PLANNING PROPOSAL REVIEW 245 MARION STREET, LEICHHARDT

RESPONSE TO INNER WEST ARCHITECTURAL EXCELLENCE PANEL REPORT (dated 4.11.2019)

GROUND LEVEL LAYOUT

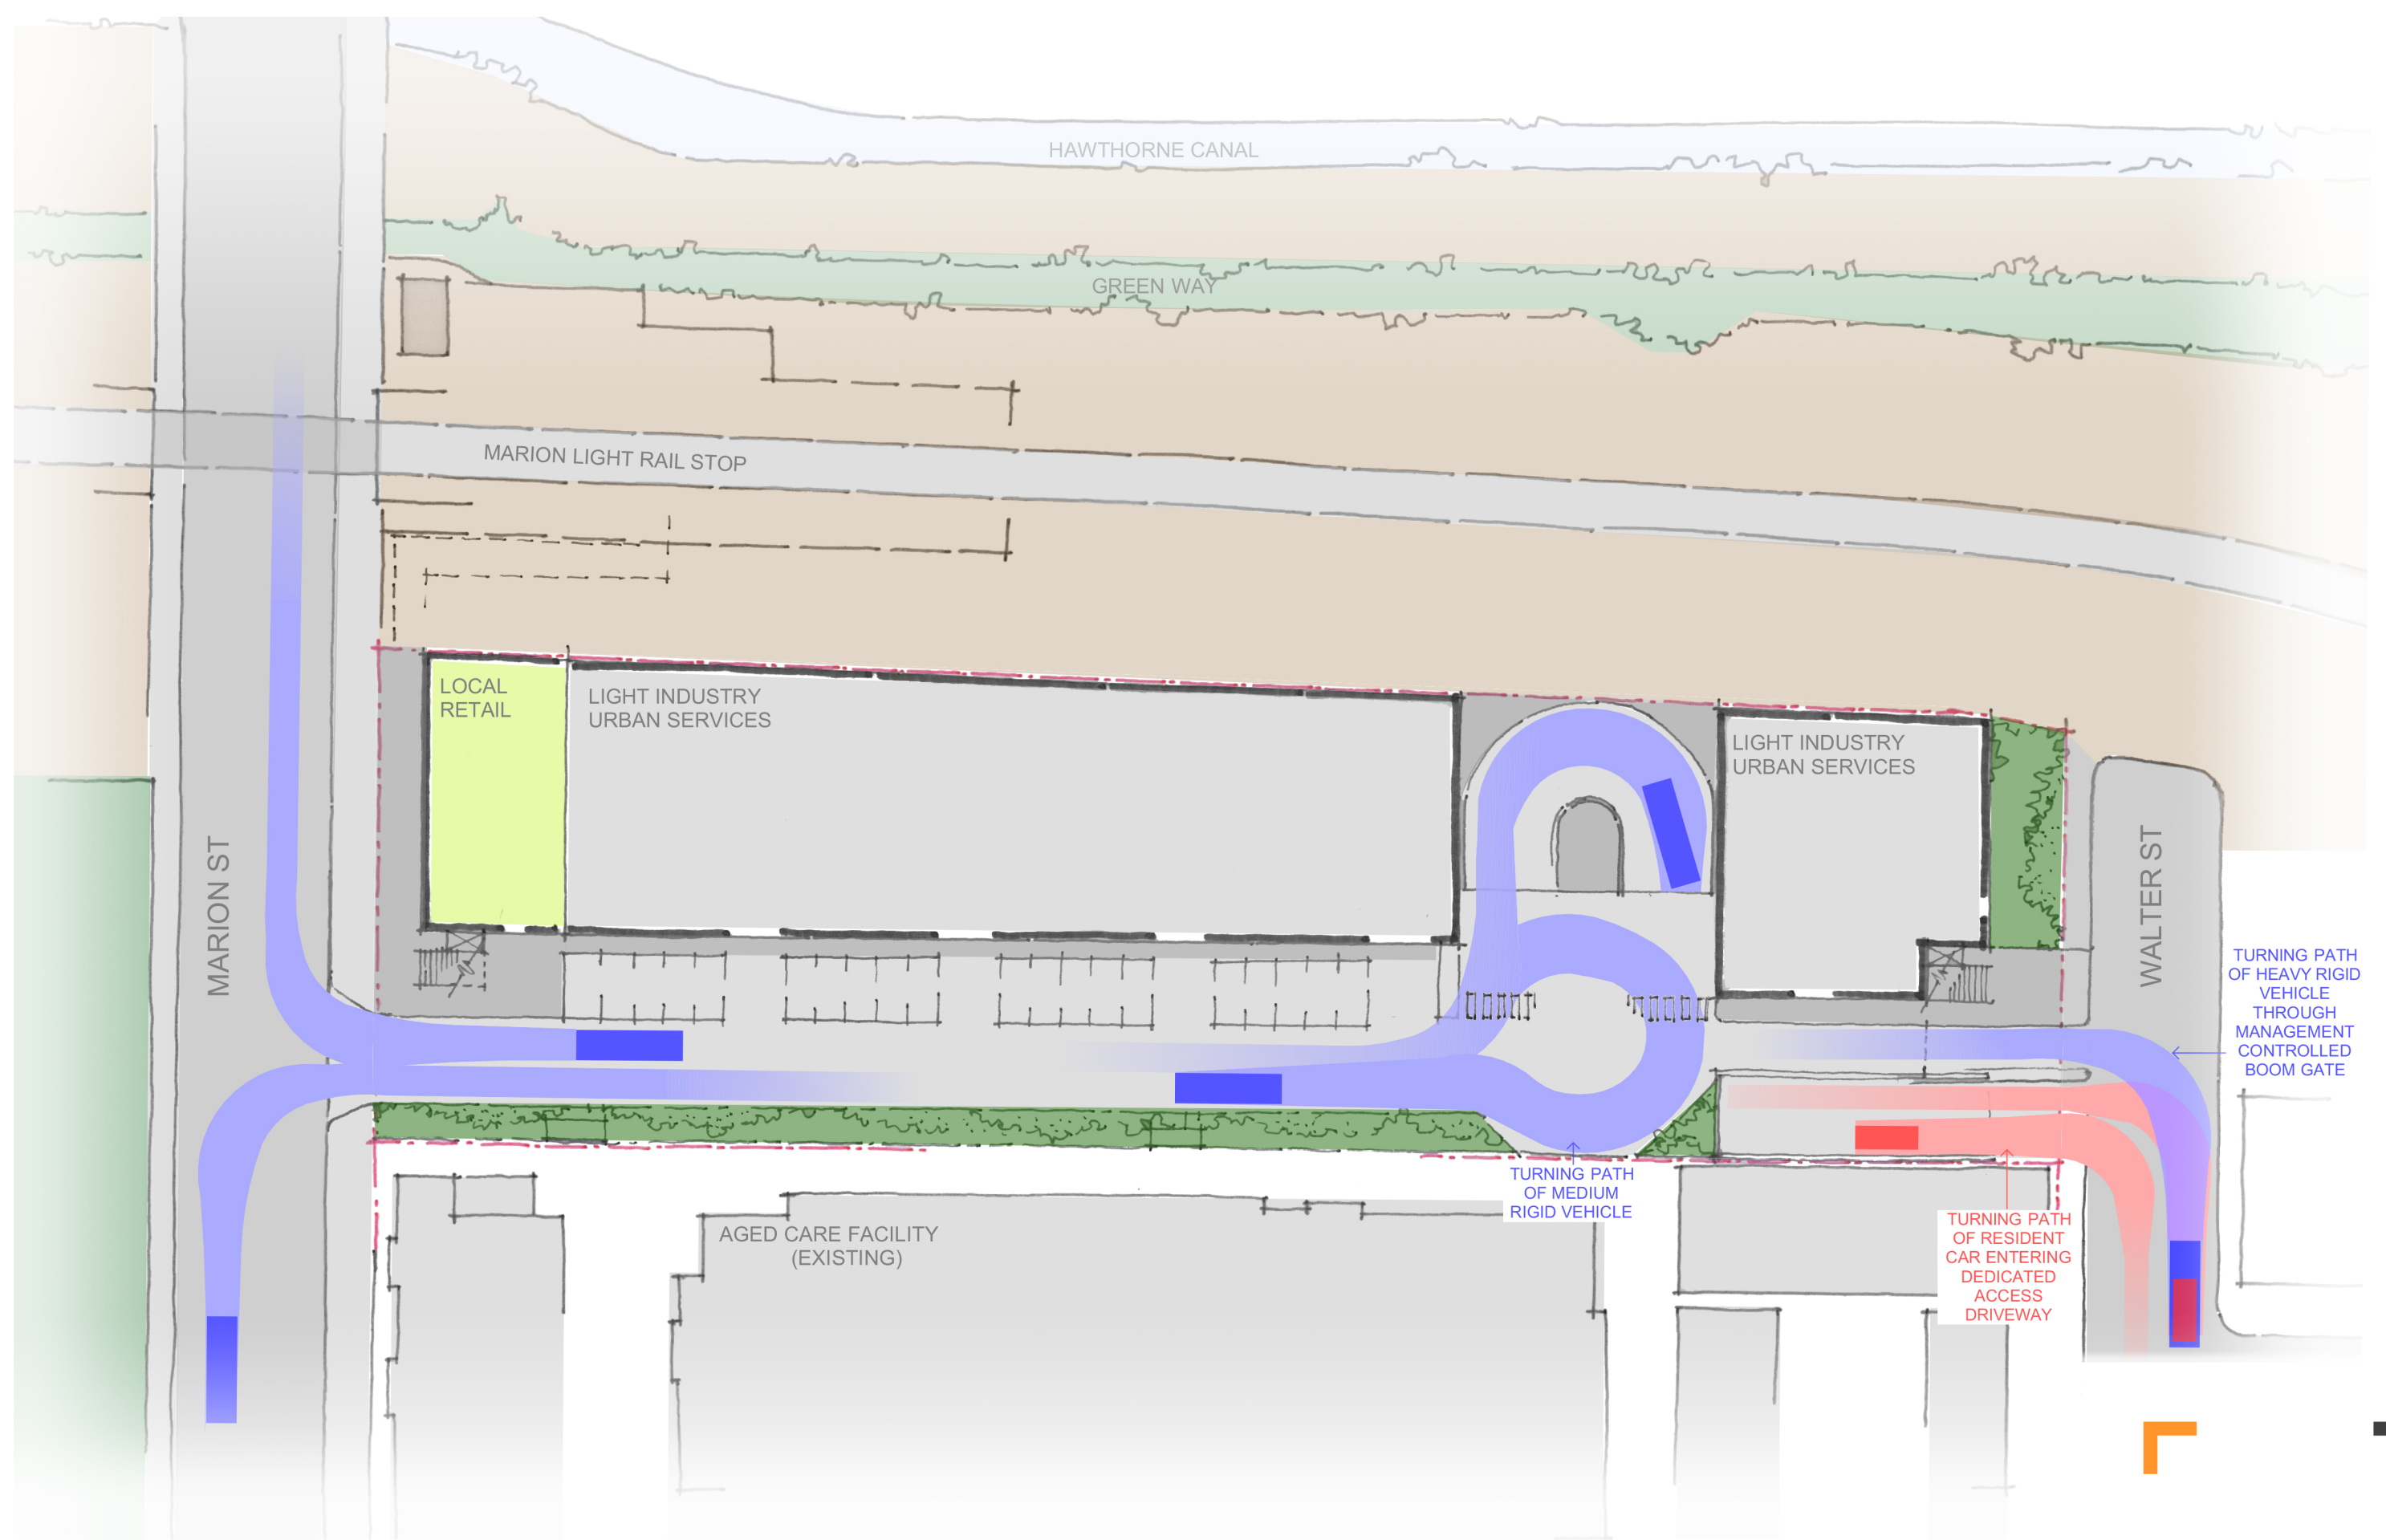
<p>b) The 'urban services' and the associated vehicle circulation driveway and ramp system results in a car-dominated environment, which is in conflict with the residential use and the desired future character of the area.</p>	<p>This comment is taken on board and is addressed in the accompanying sketch illustrating how the design could be developed with a podium level through-site link.</p> <p>This initiative would achieve the following:</p> <ul style="list-style-type: none"> Dedicated pedestrian through-site link at podium level connected by stair and lift to Marion Street, Marion Light Rail stop and Walter Street. All pedestrian residential access via through-site link at podium level. Residential vehicular access segregated and accessed exclusively from Walter Street. All Industrial/ Urban Services access at Ground Level connecting to Marion Street, with provision for controlled egress to Walter Street for waste collection vehicles and emergency services. A physical barrier provided by the elevated through-site link segregating sight lines and mitigating noise connections between the residentially operated areas and the industrial functions at Ground level.

CROSS SECTION THROUGH INDUSTRIAL COURT AND THROUGH SITE LINK

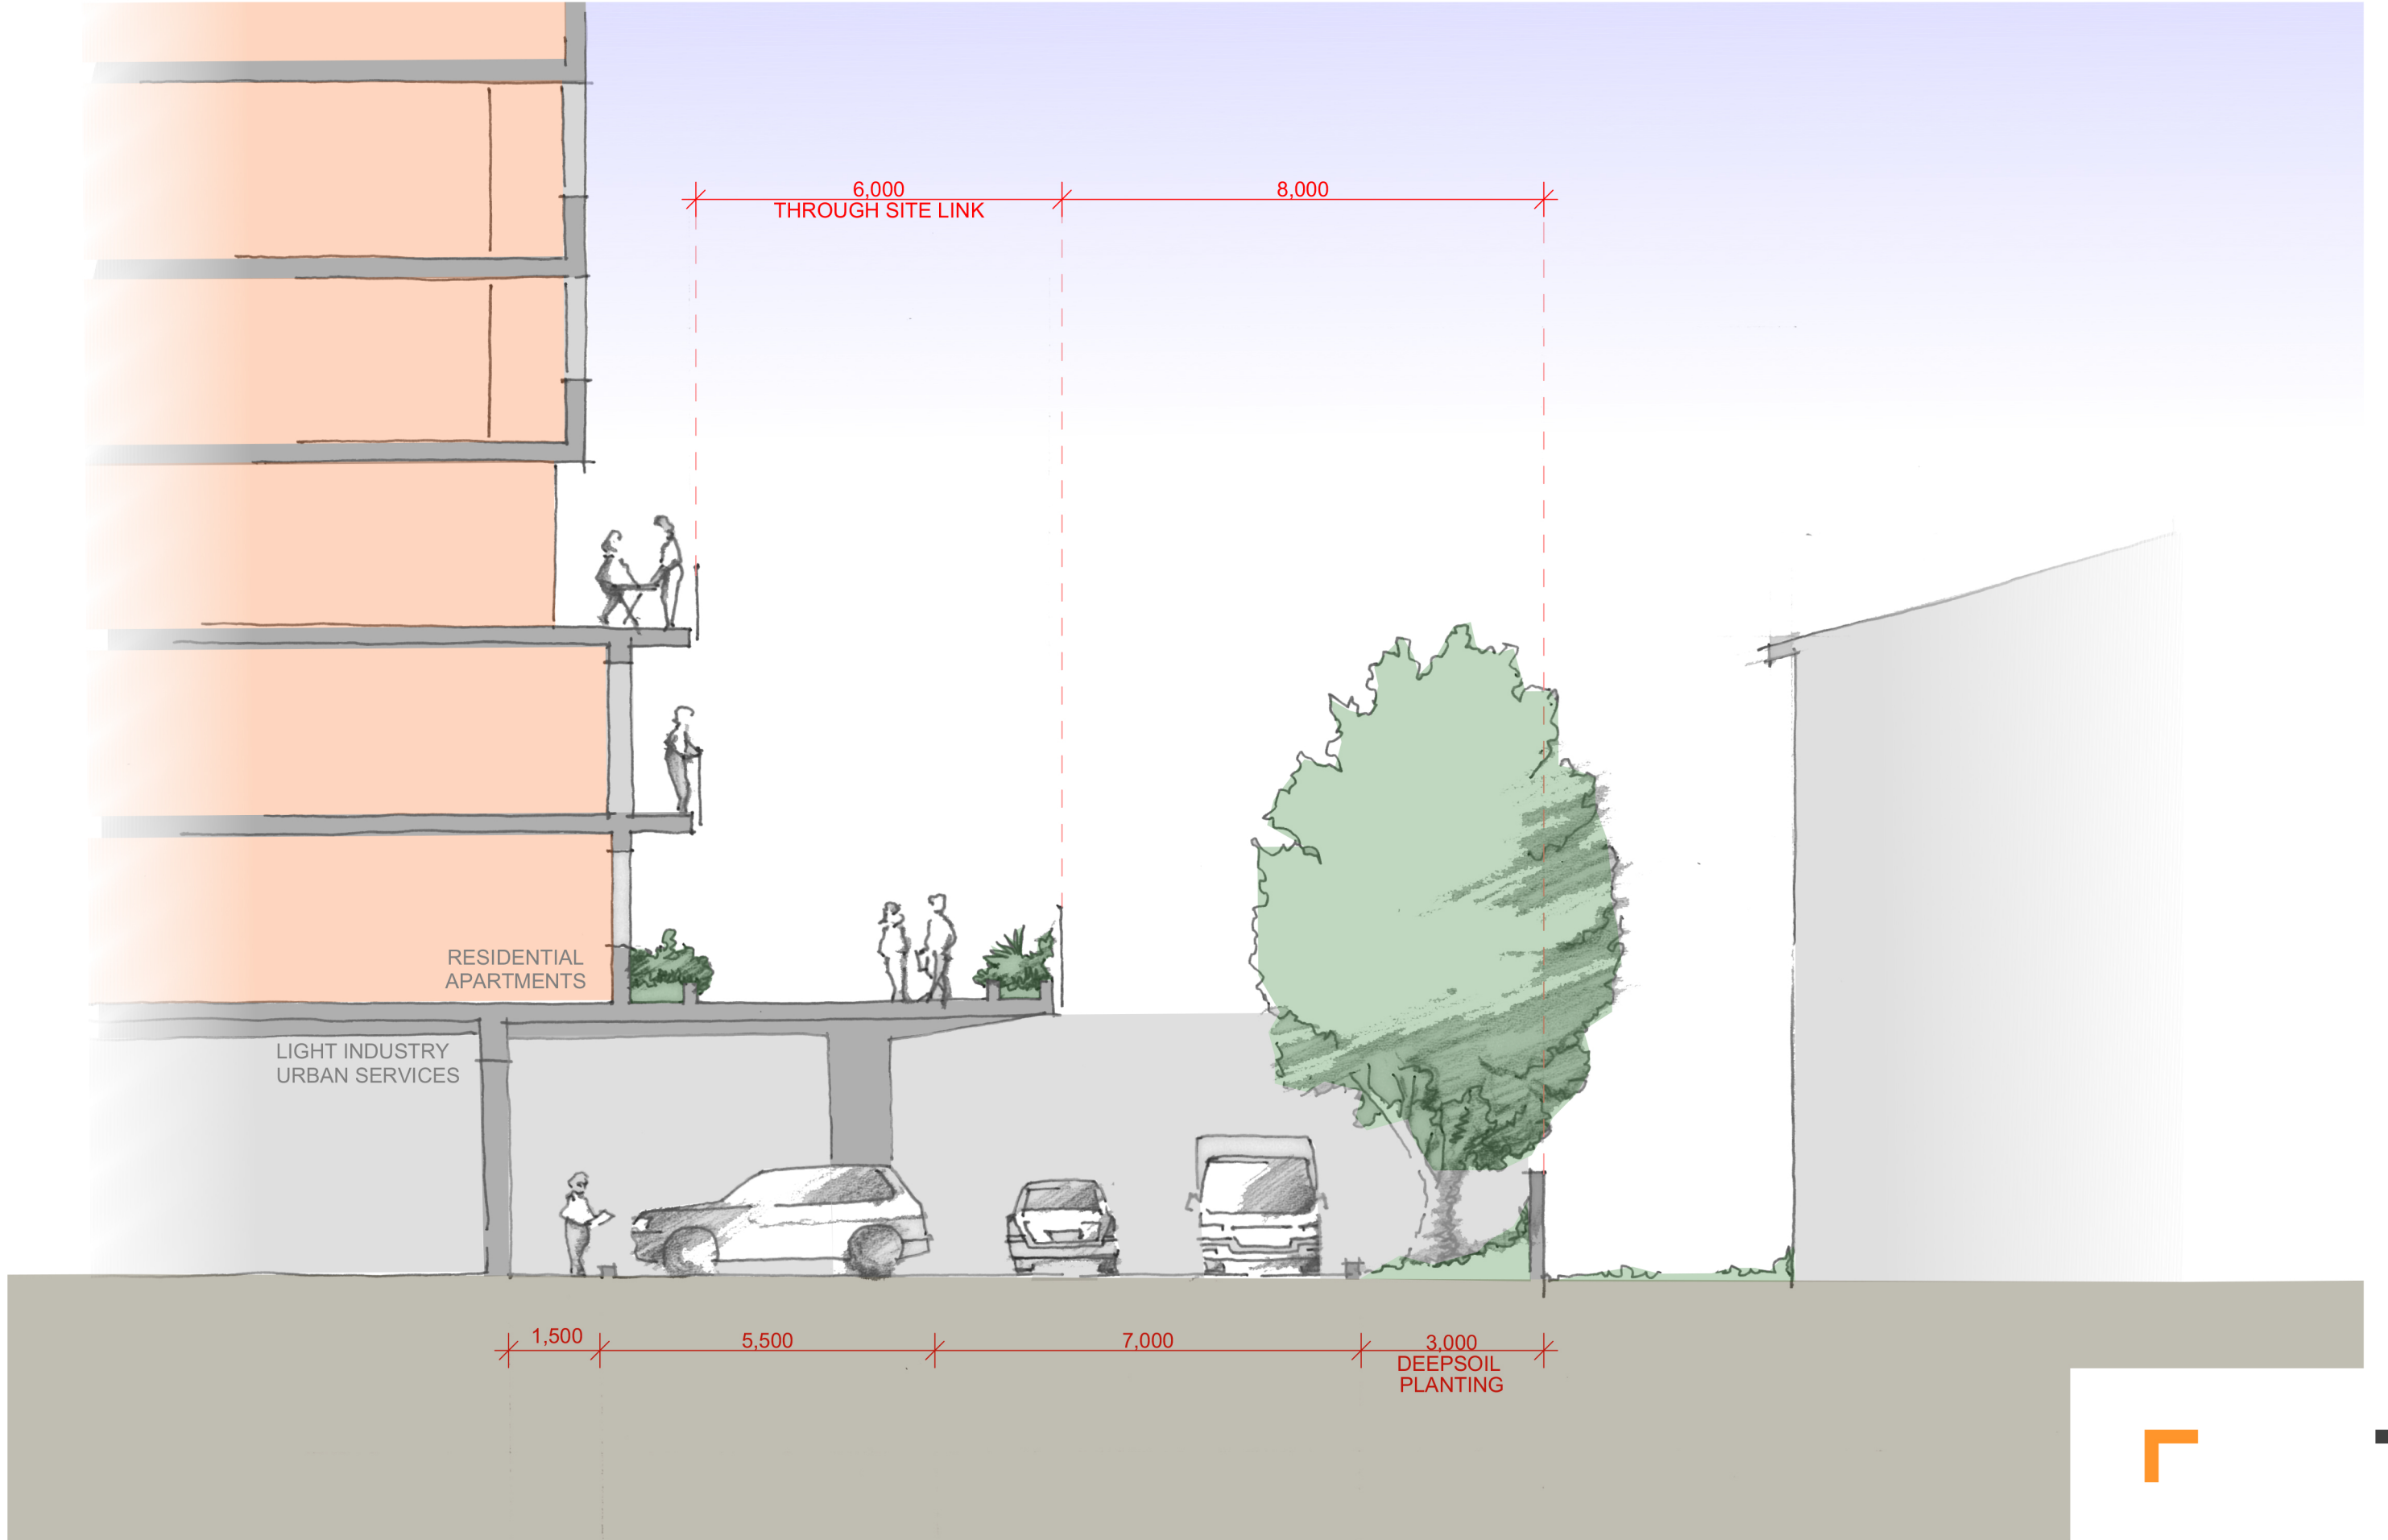
<p>c) Pedestrian access and the safe movement of residents appears to be in conflict with the proposed car-based urban services use, as they have a shared address to the internal street/ driveway.</p>	<p>A dedicated sheltered pedestrian walkway, minimum 2.5m wide, is provided along the internal roadway. However, the alternative proposal previously described would provide complete segregation between residential and employment traffic and movement.</p>
